Access Compliance Report

Public Rights-of-Way

(Curb Ramps)

Intersection ID: 2953	Main Street: COTTAGE_OAKS_DR	Cross Street: WAVERLY_LYNN_LN	Location: NW
ADA ID: C28DFD807C3E	Ramp Type: BlendTrans1	Initial Pass/Fail: Pass	Overall Compliance: No
		Severity Score: 7.75

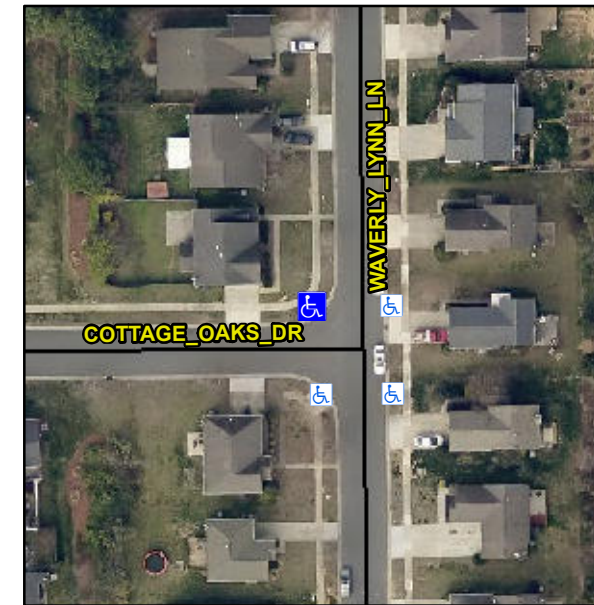
Remove & Replace Curb Ramp With Two New Directional Ramps or Equivalent. Remove & Replace Gutter.

R304.5.3, R304.2.2-Perp, R304.3.2-Para, R305.1.4, R305.2, R304.5.4
